ONSITE SEWAGE DISPOSAL SYSTEM

P 554540-13

PROPERTY ADDRESS: 13014 High Grove Road

SCHOOLEY MILL FARM
 SITE PLAN FOR BAT INSTALLATION FOR LOT 9
 13014 HIGHGROVE ROAD
 Zoned: RR-DEO
 Tax Map No. 40; Grid No. 10 & 11; Parcel No. 115 & 149
 Fifth Election District - Howard County, Maryland
 Date: April, 2014 Scale: As Shown

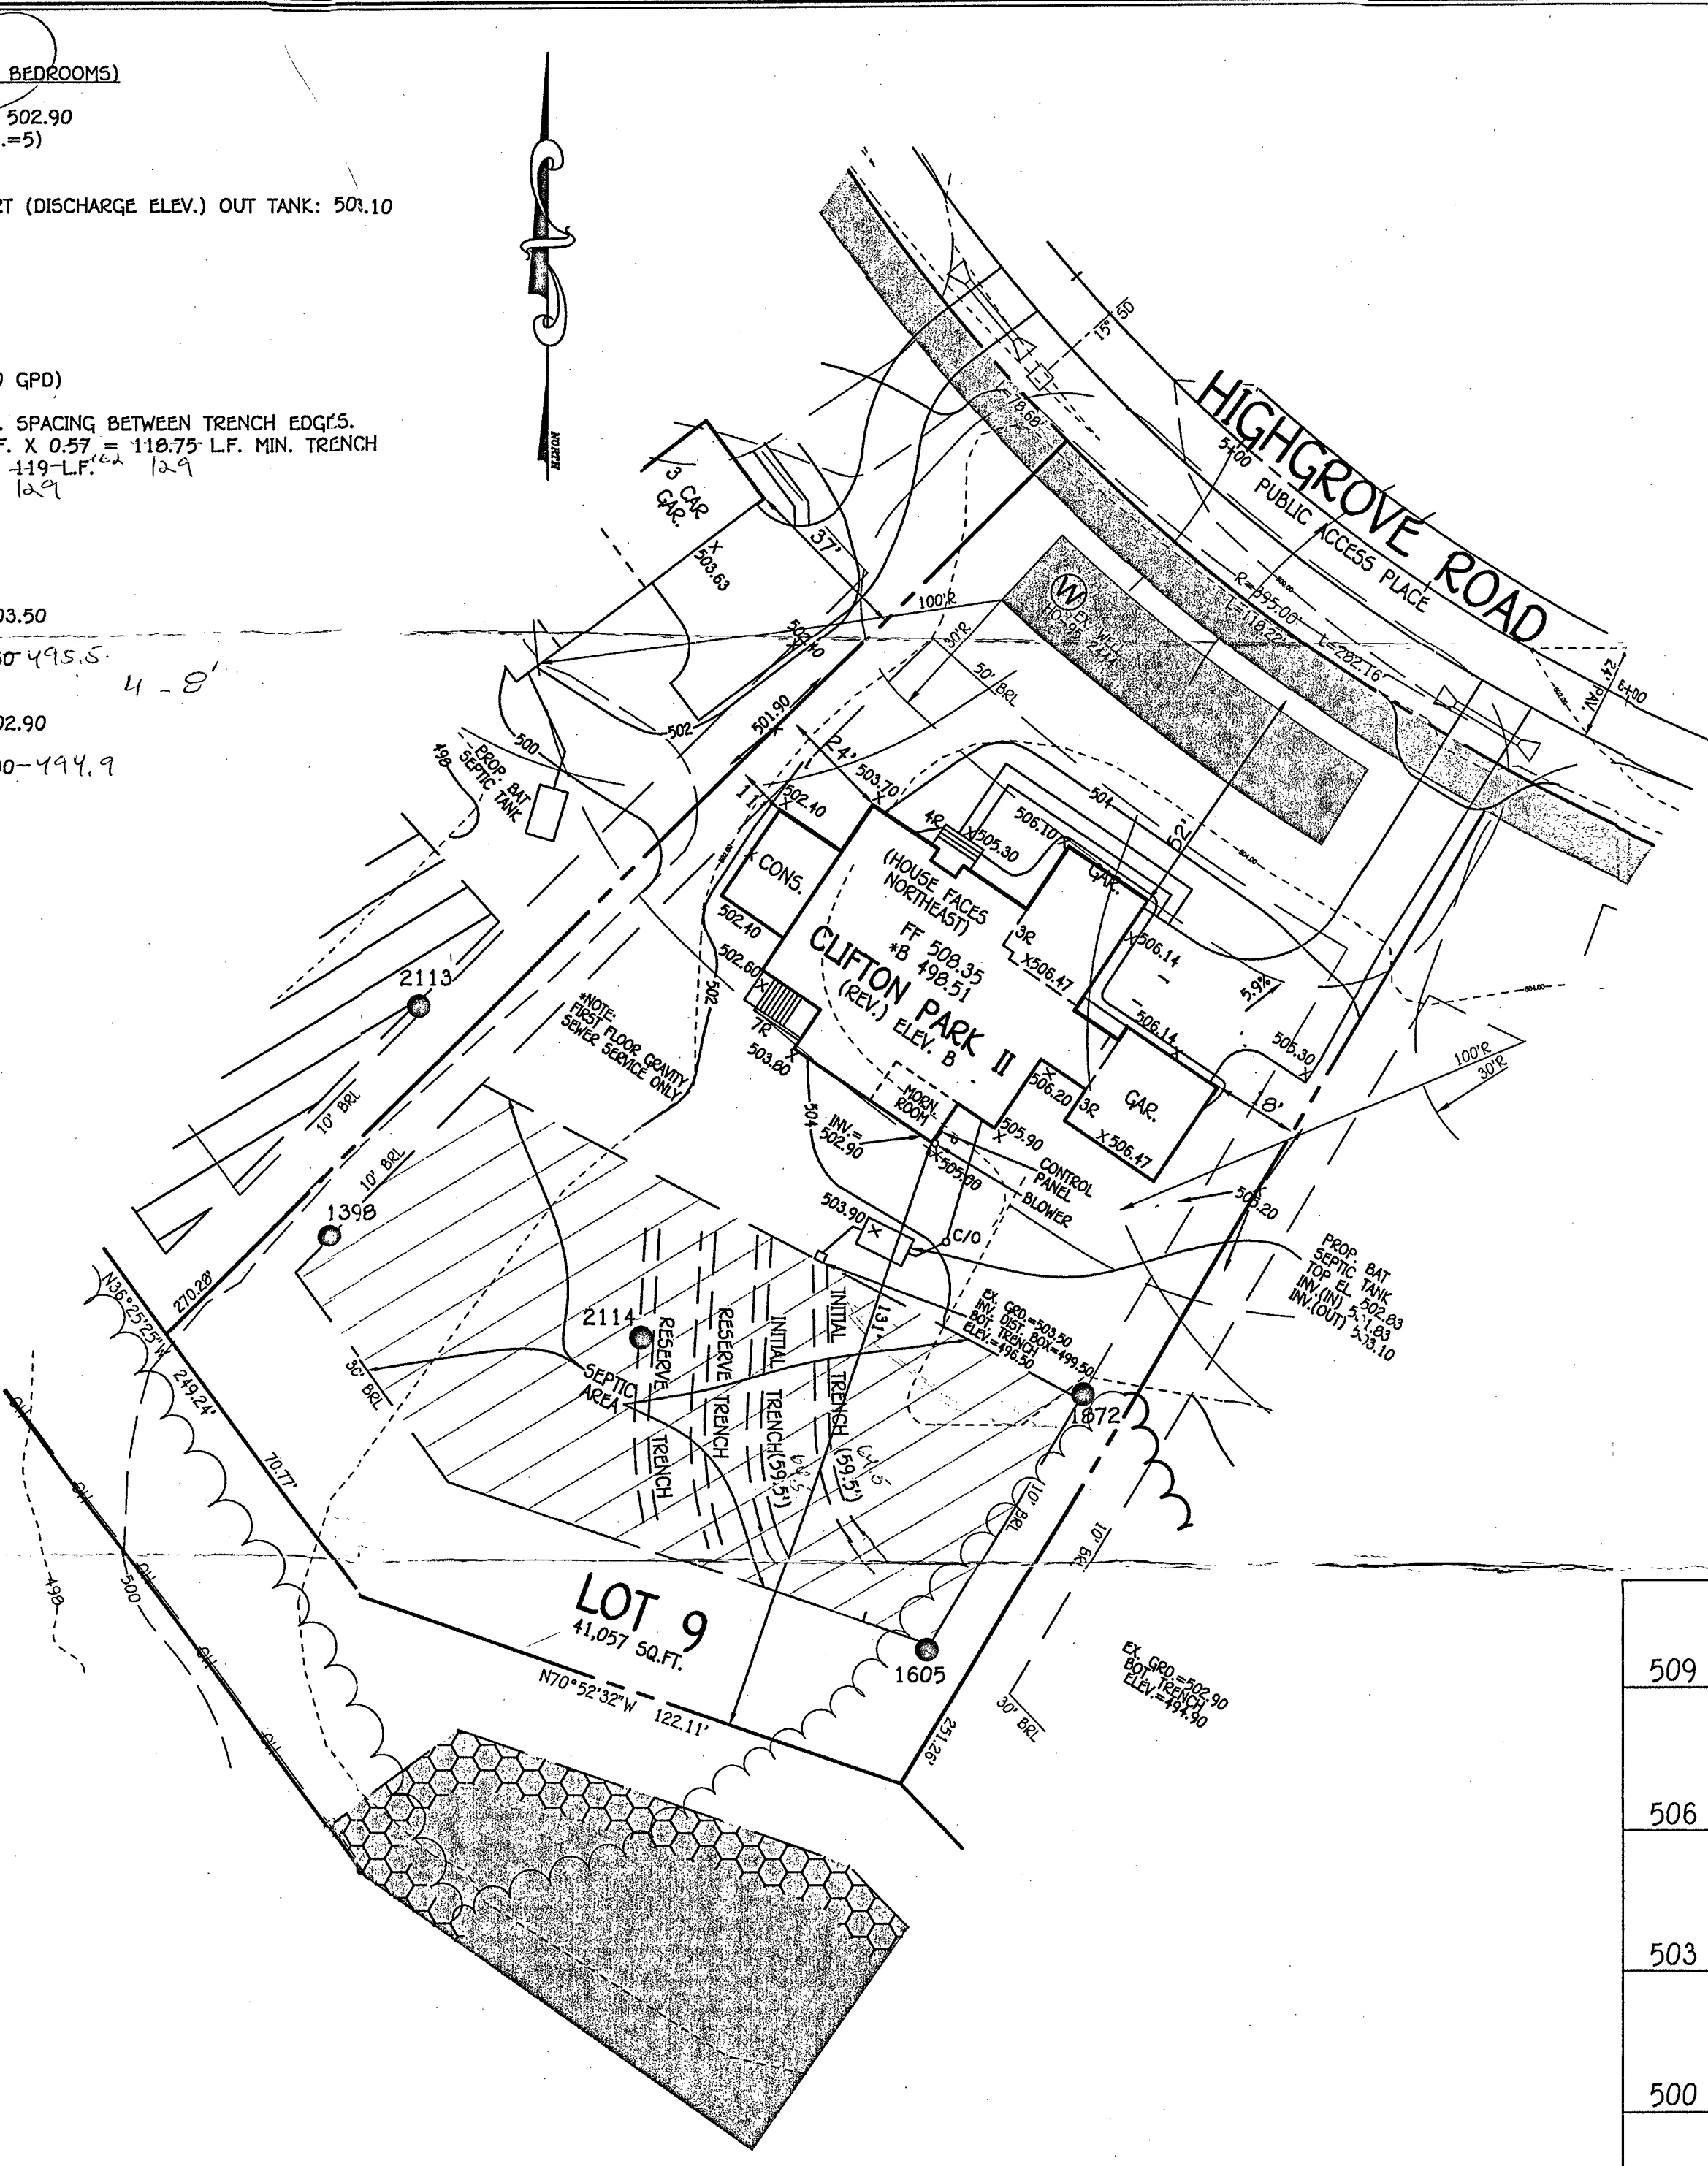
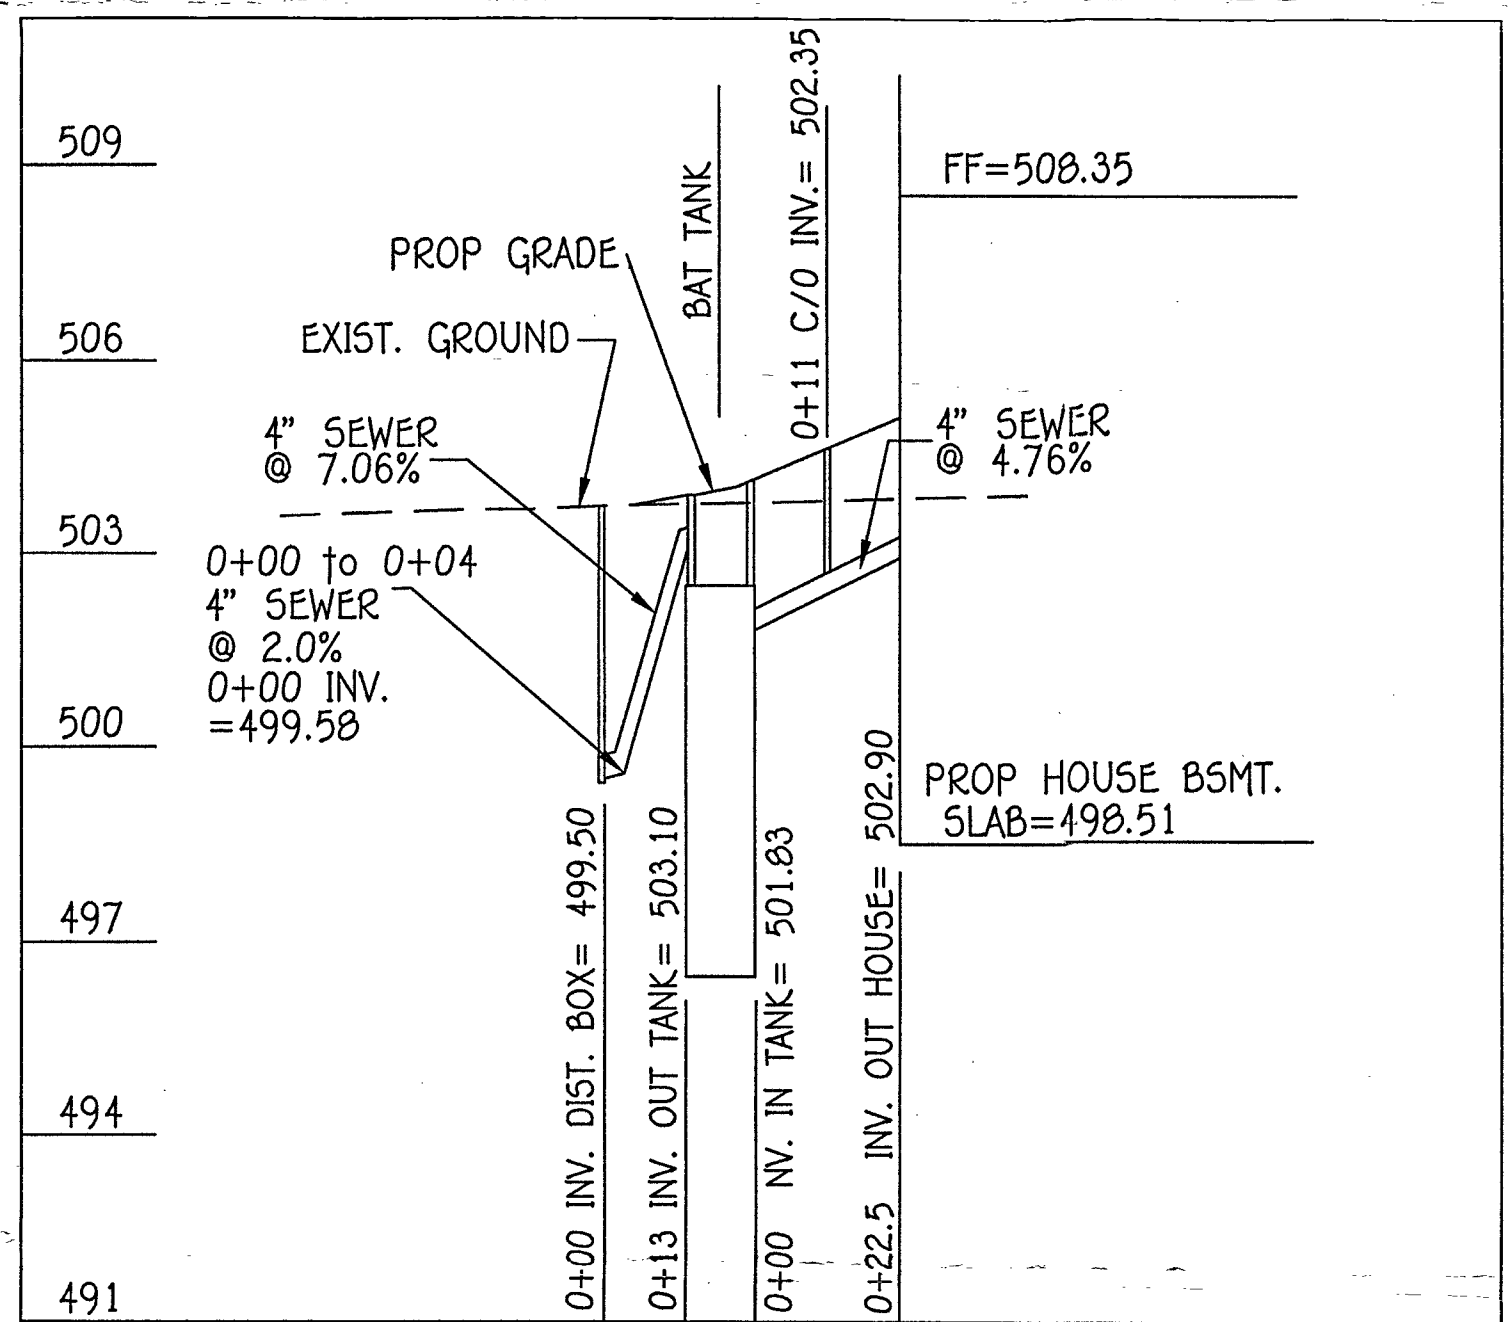
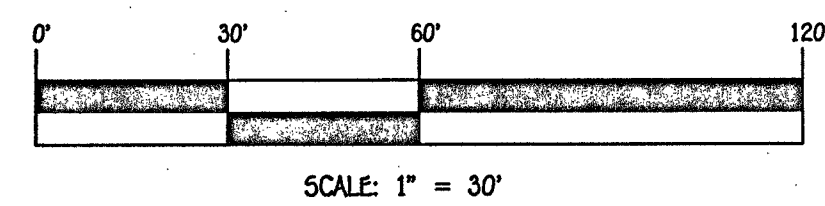
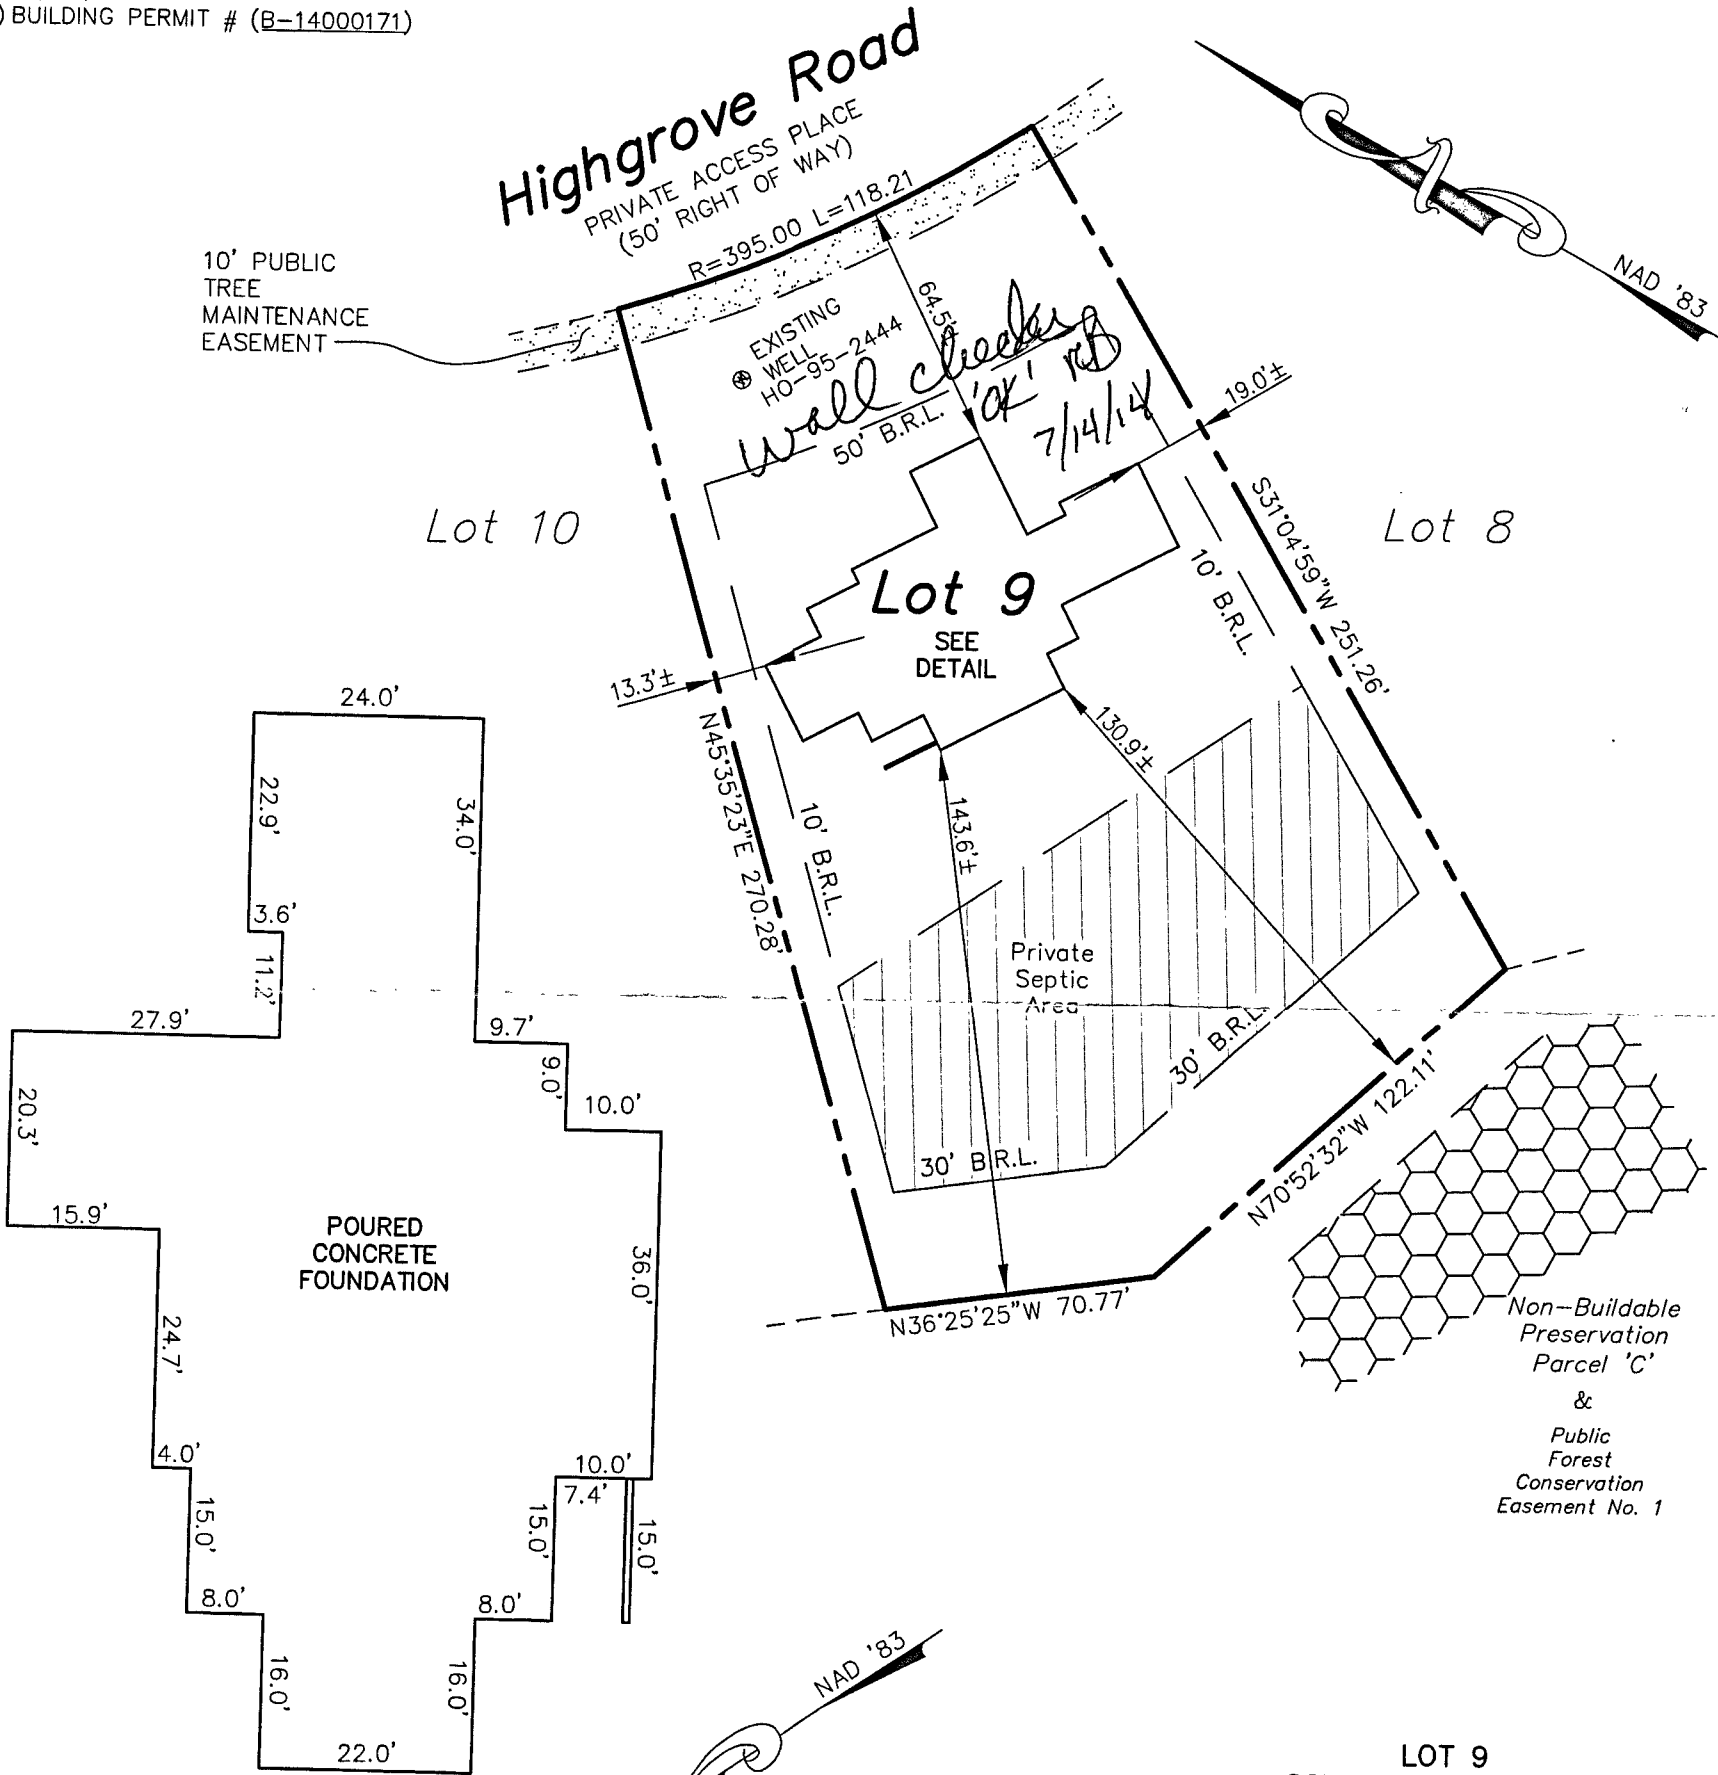
I approved the BAT plan for lot 9. Again, there were some tweaks that were partially my fault again. I don't know why I told you that the depth was 7' for all. Some were 7' and some were 8'. Lot 9 was 8', so I changed the bottom depth back to 8' on the plan. I also revised the dose and runtime for the hoot pump similar to the other two: 53g dose and 1 minute runtime. Also, same as the others, the 3' wide trenches changed the sidewall credit and changed the linear length to 129'. I changed the trenches to be 64.5' long each.

I've approved lots 6 and 7. I made a few little redline revisions to them. For lot 7 I erred in telling you a 7' bottom depth, that one was 8', so I moved the trench bottoms down to 8'. Also, on both your trench sidewall credits were wrong. You were going off of our old spec sheet, which was giving you the sidewall credit if you were using 2' wide trenches. With our new sheet, we let you decide the trench width and calculate the credit yourself to avoid confusion. For both, the difference was about 5' per trench in additional length. I just redlined the numbers and added the length onto the end of each trench.

Also, the hoot dose and runtime is based on the pump curve. Your pump curve for both shows the pump will dose at 53 gpm. You stated a runtime of 23 minutes, which would be a dose of 106g. After a talk with Nancy Mayer, I realized that these systems would do best with a dose around 50g, so I changed your runtime to 1 minute on both.

I've reviewed the woodmark BAT plan and there are some tweaks needed on the trench design. You show 94 linear feet with trench bottoms at 7'. Our specs indicate effective area beginning at 6', bottom max depth at 8'. If the trenches were taken down to 8', we would calculate $3 \text{ bedrooms} \times 150 \text{gpd} = 450 \text{g} / 0.8 = 562.5 / 3' \text{ wide trenches} = 187.5 \times 62\% \text{ sidewall credit for } 2' \text{ of sidewall} = 118 \text{ linear feet of trench required}$.

Hi Dave. I reviewed the Schooley Mill plans. I had Andrew review them and I apologize that I didn't catch the following issues for lot 7 and 9 on earlier reviews. I was focused on the septic design that I missed the well problem. Lot 9 wellbox is within the 30' setback to the house location. Lot 7 wellbox is within the 10' setback to the driveway.

Otherwise, for all lots the approved trench bottom depth is 7', but on all you have trench bottom depths at 8'. Also, we need the trench invert elevations for all. We also need the trenches within each system to be exactly equal length. I don't think that will be a problem on any of these. What is helpful to us is to include a chart or note indicating the trench depths and specs. I've attached a copy of an example that we like.

Also, I've learned that the Hoot system pump probes are at set locations, but the length of time the pump is on can be programmed, which is what gives the dose. I had asked for an elevation of the pump on float and a dose volume. We didn't get the pump elevation on these revised, but what we could get is a note under the dose stating the run time correlating to the rate of the pump selected that matches the dose given. A rule of thumb for a dose going to a d-box could be about 1/6 design flow or around 100g. For example, lot 7 has a pump with a rate of 53gpm. You could specify a dose of 106g and a runtime of 2 minutes.

- All of the plans need to show the pump on elevation and dose volume.
- All plans need to show trench details: ground elevation, invert elevation, bottom elevation for each.
- Lot 6: hoot tank location is in the middle of a proposed swale. They could move it over right by perc hole 1663.
- Lot 7: the building permit states 5 bedrooms, you revised the plan down to 4 bedrooms
- Lot 9: the sewer grade states 7%, but is really 4.7% (FYI, anything greater than 5% should level off to 2% in the last few feet before the tank)
- Lot 9: the d-box should go at the top edge of the easement for an end feed to the trenches.
- Lot 4: the d-box should go to the corner of the easement for end fed trenches.

We need to see the trenches bottom out at 8' and give us a linear length of 118' showing two 59' trenches. If you like, we could sit down to go over this or other plans in the works to make sure we are on the same page. Thanks. You could even come in to redline these things on the existing plan if you want to speed things up.
